# **Rampion 2 Offshore Wind Farm**

## **Written Representation**

**South Downs**  
National Park Authority

**DATE: 12 December 2023**

**Fig. 3** South Downs Seascape Sensitivity Summary Map

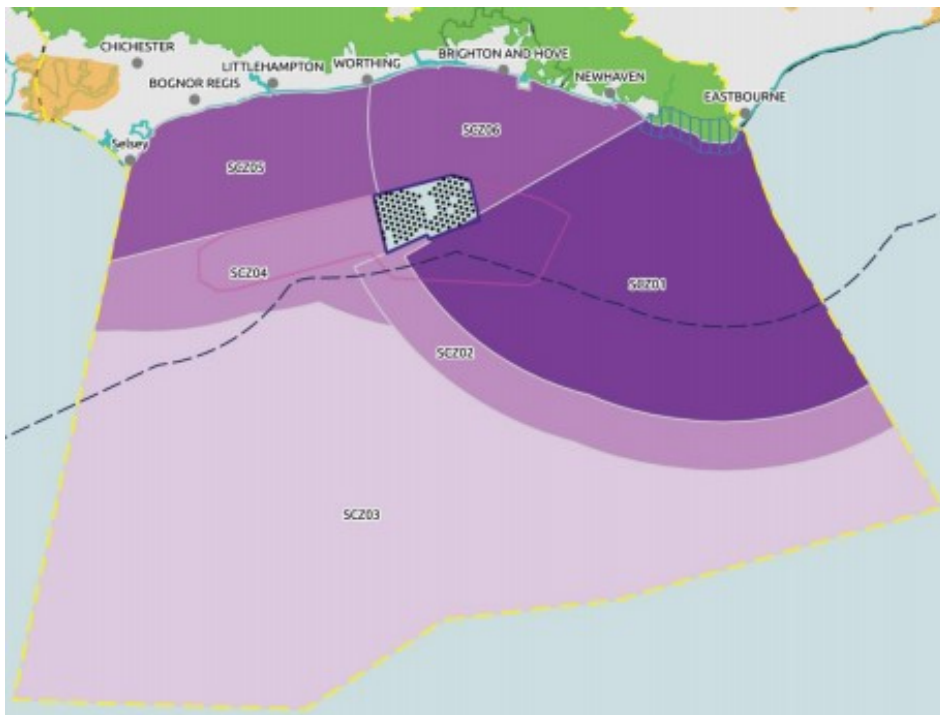
- 3.4.4. The SDNPA commissioned a further study into seascape sensitivity as it relates to the proposed development in 2021, which is included at Appendix C. This identifies six seascape character zones of sensitivity associated with the National Park, as shown in Figure 3 below. The darkest shade (i.e. SCZ1) indicates the area with the highest level of sensitivity, with the lightest shade (i.e. SCZ3) indicating the lower end – in this case medium-low sensitivity. The study identifies different levels of sensitivity, though “a gently curving coast, the iconic chalk cliffs to the east, the special qualities of the breath-taking panoramic views, tranquillity and unspoilt character, combined with the wildness that the seascape imparts, all contribute with other factors to enhance the value and sensitivity of the area”.

- 3.4.5. The study goes on to propose a set of recommendations in respect of the design, layout and height of a proposed array that would go some way to resolving the concern. These include:
  - a) Development should only occur within the Extension Area west of Rampion I.
  - b) Turbines should not exceed 225m to blade tip in height.

- c) Clear separation between Rampion 1 and 2 to minimise the horizontal extent.
  - d) Turbine layout is designed in coherent blocks.
  - e) Full north to south extent of the extension area should be utilised to maximise the size of east/west gaps between the arrays.

**Fig. 4** Scheduled Monuments in relation to Cable Corridor

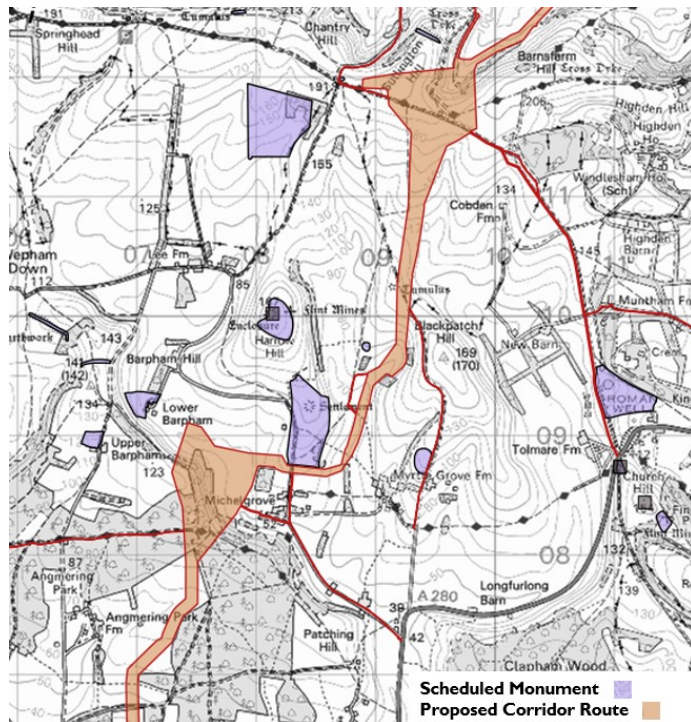
- 3.10.2. The proposed route of the cable corridor would come in close proximity to a Scheduled Monument (Itford Down) and through an area of known prehistoric industrial activity (see Fig 4).

- 3.10.3. Blackpatch and Harrow Hills sit on high points either side of the valley containing the proposed route corridor. Given both sites are of a prehistoric industrial nature, it is probable that the valley contains significant potential for settlement evidence from the early prehistoric (and therefore may represent some of the earliest evidence for Neolithic settlement in Britain). The landforms themselves suggest significant sediment build ups within the dry valley between both sites, with potential evidence for Neolithic and other periods lying deep in the valley profiles. This means that geophysical data, which is all that has informed this section of the route (to date) is unlikely to provide a sufficiently detailed evidence base on which to base decisions relating to route options (Document Reference APP-066).

- 3.10.4. Of the excavations that have occurred linked to the flint mining complexes of Blackpatch and Harrow Hill, it is clear that the mines became the focus for Bronze Age burial monuments constructed after mining had ceased. As many Bronze Age barrows and similar funerary monuments were plough damaged during intensive world war and post war agricultural practices, there is also the potential for below ground Bronze Age archaeological evidence not necessarily recorded or known. A summary of significant archaeological sites and finds in the area is included at Appendix D. It would appear highly unlikely that the route could be achieved without substantial permanent destruction of the historic environment.
